Access Compliance Report

Public Rights-of-Way

Intersection ID: 27891	Main Street: JOCKEY'S RIDGE DR	Cross Street: JOHN K HALL WY	Location: E
ADA ID: 637CC9AAEAE0	Ramp Type: Perp	Initial Pass/Fail: Fail	Overall Compliance: No
		Severity Score: 10

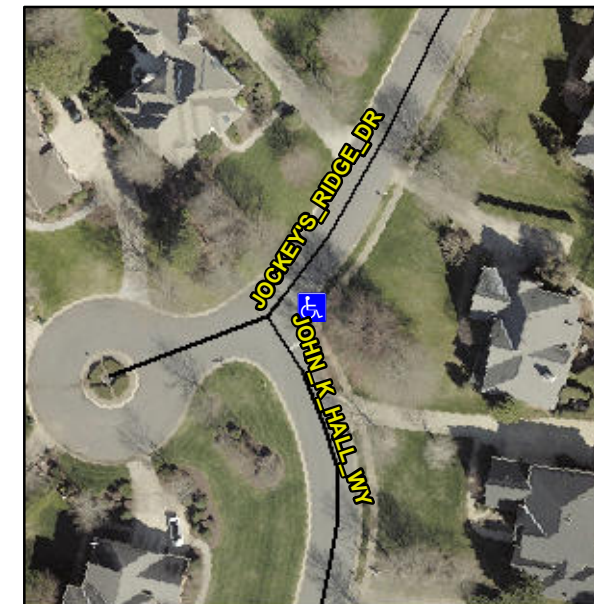
Not Found, R304.5.1

Compliance	Description	Data	Compliance	Description	Data
N/A	Ramp Length (in)	45.0	Yes	Ramp Slope (%)	5.2
No	Ramp Width (in)	45.0	Yes	Ramp XSlope (%)	2.8
N/A	Flare Type LT	N/A	N/A	Flare Type RT	N/A
N/A	Flare Slope LT (%)	N/A	N/A	Flare Slope RT (%)	N/A
N/A	Flare Traversable LT?	N/A	N/A	Flare Traversable RT?	N/A
N/A	Landing Length (in)	N/A	N/A	DWS Provided?	N/A
N/A	Landing Width (in)	N/A	N/A	DWS Contrast?	N/A
N/A	Landing Slope (%)	N/A	N/A	DWS Length (in)	N/A
N/A	Landing X Slope (%)	N/A	N/A	DWS Full Width?	N/A
N/A	Landing Curb? (Y/N)	N/A	N/A	DWS Offset (in)	N/A
N/A	Shared Landing?	N/A			
N/A	Gutter Ponding?	N/A	N/A	Gutter Slope (%)	N/A
N/A	Gutter Lip Ht (in)	N/A	N/A	Gutter X Slope (%)	N/A
N/A	Painted X Walk1?	No	N/A	Painted X Walk2?	N/A
	X Walk 1 Direction	To NW		X Walk 2 Direction	N/A
N/A	X Walk 1 Width (in)	N/A	N/A	X Walk 2 Width (in)	N/A
	X Walk 1 Slope (%)	1.1		X Walk 2 Slope (%)	N/A
	X Walk 1 X Slope (%)	3.2		X Walk 2 X Slope (%)	N/A

Remove & Replace Entire Ramp.
